# TRACKSTER

## SERVICE BULLETIN

### HYDROSTAT INLET LINE SET

PART NO. 883231

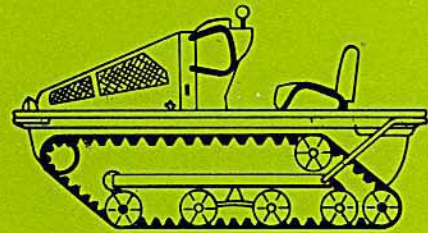
An improved oil inlet system has been incorporated on all 1975 model TRACKSTERS.

The above set can be installed on all prior model TRACKSTERS.

Installation of this set will decrease the time required in priming the hydrostats as occasionally experienced in sub-freezing temperatures.
